Figure 8: Integration of foreshore works between Barangaroo Point and Barangaroo Central (source: BDA)

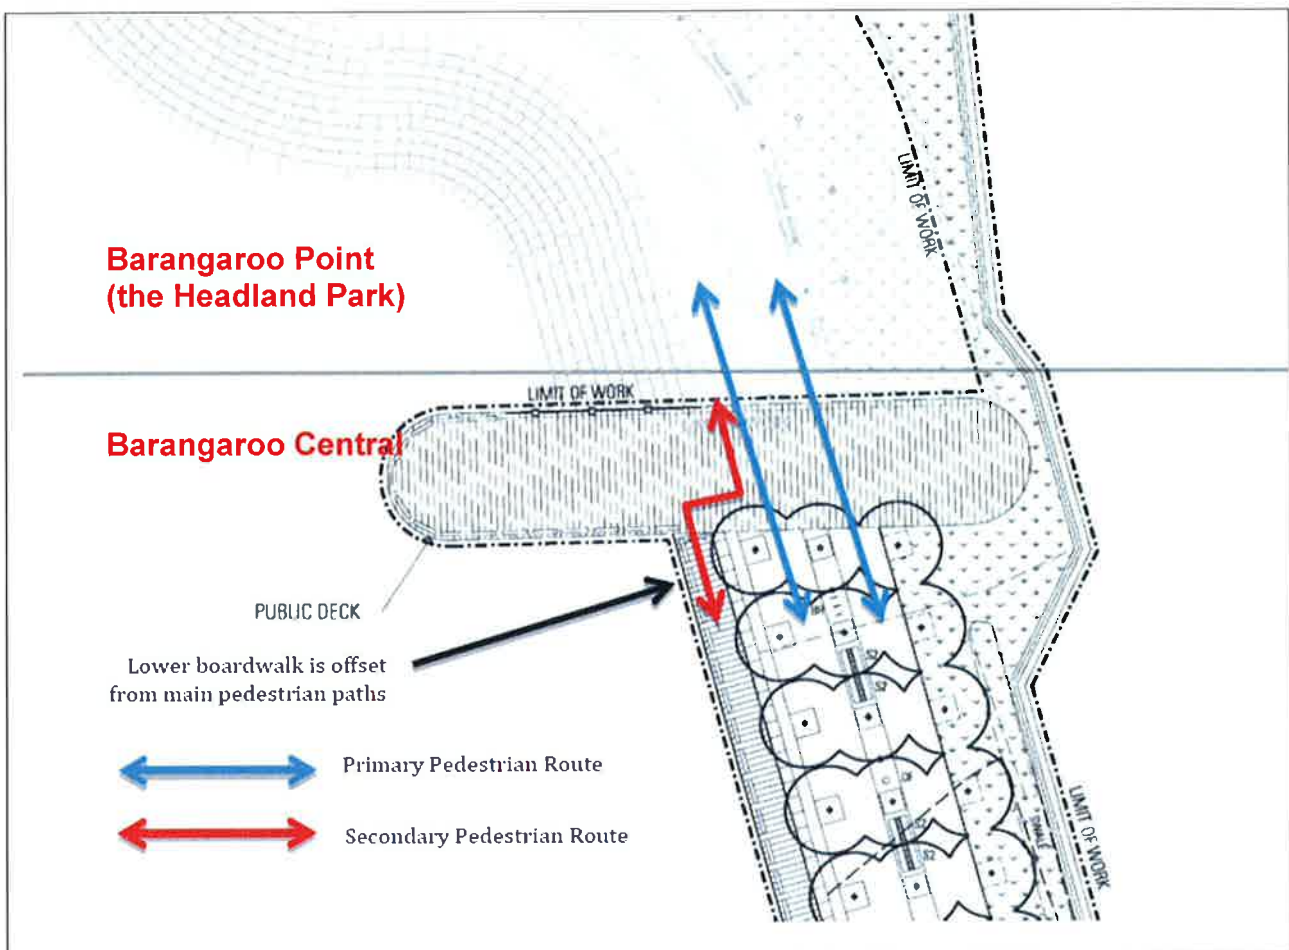
- the interface between Barangaroo Central and Barangaroo Point (the Headland Park) has been designed to direct the main pedestrian traffic flows to the upper level of the Barangaroo Central Promenade (refer to **Figure 8** below);

Having considered the applicant's Response to Submissions, the Department is satisfied that the amended design, despite the reduction in the useable width of the boardwalk, will continue to facilitate public access to the foreshore consistent with the design principles in the Barangaroo Concept Plan, and will coherently integrate and provide a sufficient level of connectivity to the Headland Park and the surrounding public domain. Furthermore, whilst the final design for foreshore promenade for Stage 1B of Barangaroo South is unknown, the Department is satisfied that the constructed detail for Barangaroo Central can be accommodated in the future design and therefore, is capable of seamlessly integrating with the neighbouring land to the south.

Figure 10: Proposed promenade ramp, seawall and public deck

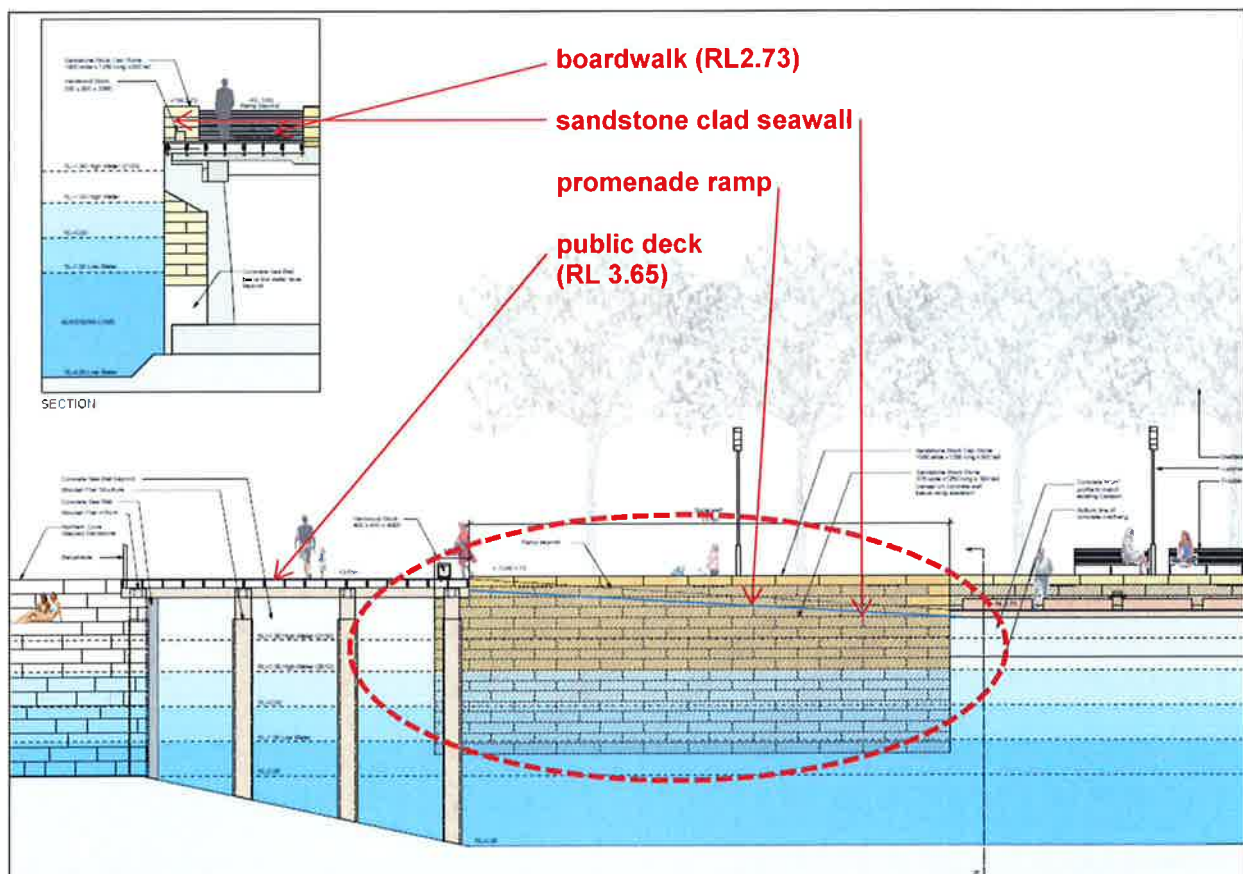
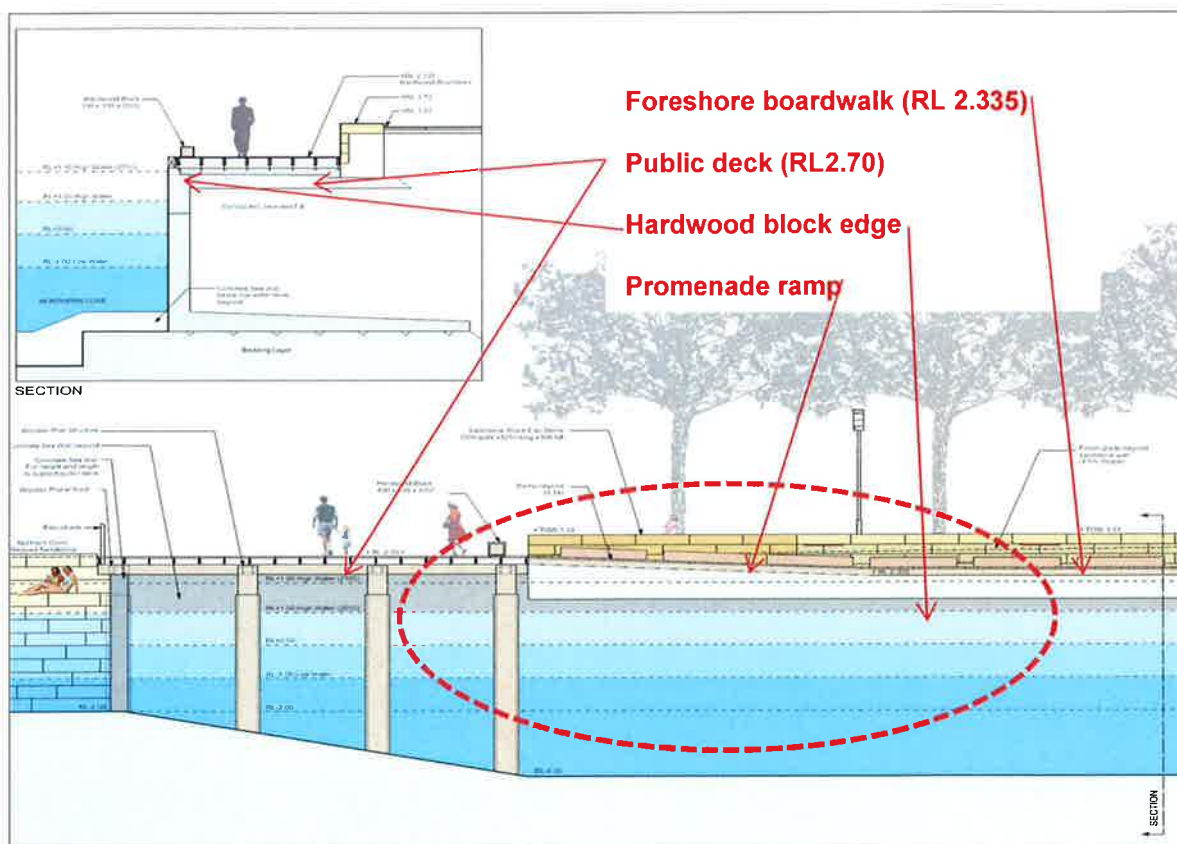
The approved design for a portion of the seawall adjacent to the public pier incorporates feature sandstone cladding, as illustrated in **Figure 9** below. In this location, this section of the seawall extends to form the outer wall of the promenade ramp, which provides direct access to the public deck (RL 3.65).

MOD 1 proposes a reduction in the finished height of the public deck from RL 3.65 to RL 2.70 and subsequently, changes to the design of the seawall. Consequently, the seawall no longer extends to form the outer edge of the promenade ramp and instead the timber boardwalk gently ramps up to align with the proposed reduced height the public deck (RL 2.70). The western edge of the timber boardwalk is now proposed to be edged in hardware blocks and would be consistent with the remainder of the boardwalk, thereby eliminating the requirement for the sandstone-clad section of the seawall. The Department also notes that sections of the boardwalk relative to the public deck are also proposed to be reduced in height by some 0.395 metres to levels at or above RL 2.335 in order to integrate with the public deck.

The approved and proposed designs for the foreshore promenade are illustrated in **Figures 9 and 10** below.

The proponent has submitted additional information, including civil works drawings, to demonstrate that the construction of the timber boardwalk and the public deck has complied with Condition C9. As illustrated in **Figure 10**, the new levels for the public deck and the boardwalk appropriately integrates with the new finished levels for the promenade and negates the need for the extended seawall. On this basis, no objection is raised to the modified design.

Figure 11: Typical paving detail (Source PWP Landscape Architecture)

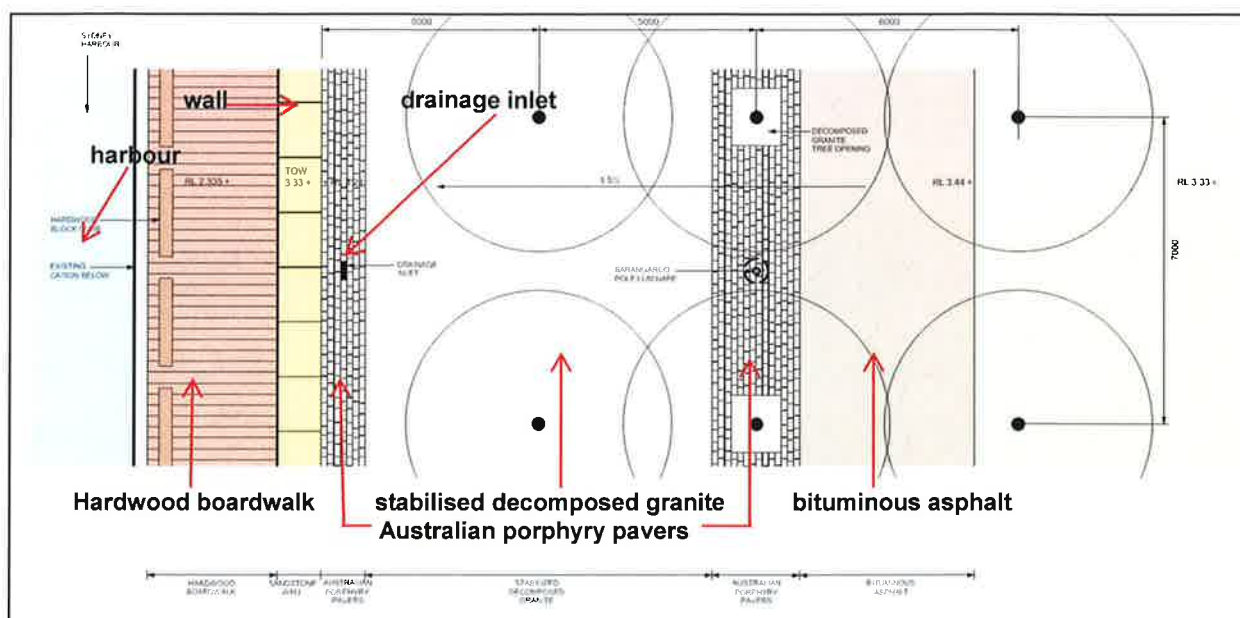
The approved surface materials for the foreshore promenade are unmodified by this modification application and the use of stabilised decomposed granite has been approved as a surface material, as illustrated in **Figure 11** below. Notwithstanding this, the applicant has advised that despite decomposed granite being approved as a paving material, it does not comply slip resistance requirements of AS/NZS 4586:2004 and therefore, is unable to comply with Condition B5.

In order to ensure administrative consistency across all development approvals issued for Barangaroo and furthermore, to ensure a consistent and integrated surface treatment for all footways, the Department recommends that Condition B5 be amended in line with recent amendments made to Condition B37 of MP10_0048 MOD 5. In doing so, the Department acknowledges that the decomposed granite surface is set behind a sandstone wall and therefore, the risk of the paving becoming destabilised as a result of sea level rise, storm surge and wave action will be minimised. Furthermore, it is noted that drainage inlets are proposed to be constructed at regular intervals in adjoining porphyry paving to enable the combined surface area to suitably drain in a storm event (refer **Figure 11**, above).

Figure 12: Promenade section showing tree planting (Source: PWP Landscape Architecture)

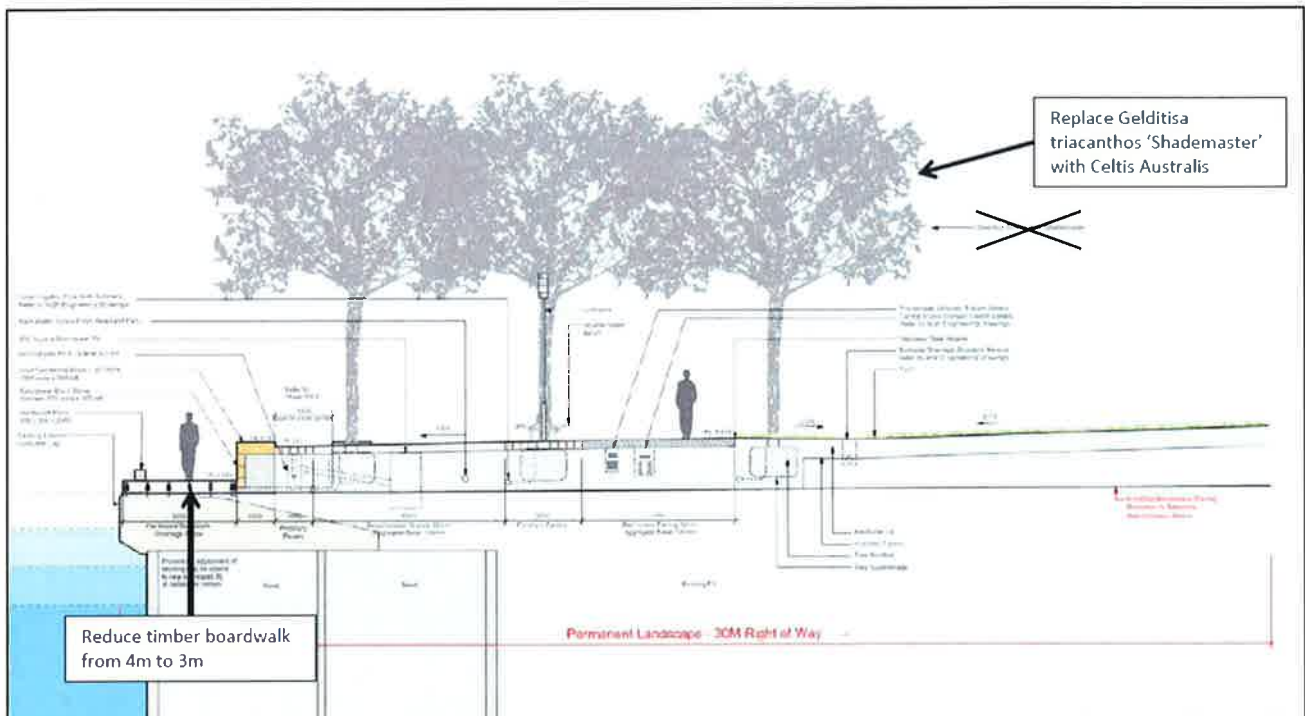
The Department also considers the changes proposed to the spacing (layout) of the foreshore planting to be inconsequential. In this regard, the three rows of trees would be maintained along the foreshore promenade, as illustrated in **Figure 12** below. This would continue to suitably embellish the landscape quality of the foreshore and will reflect the established design principles and overall concept of the Barangaroo waterfront promenade.
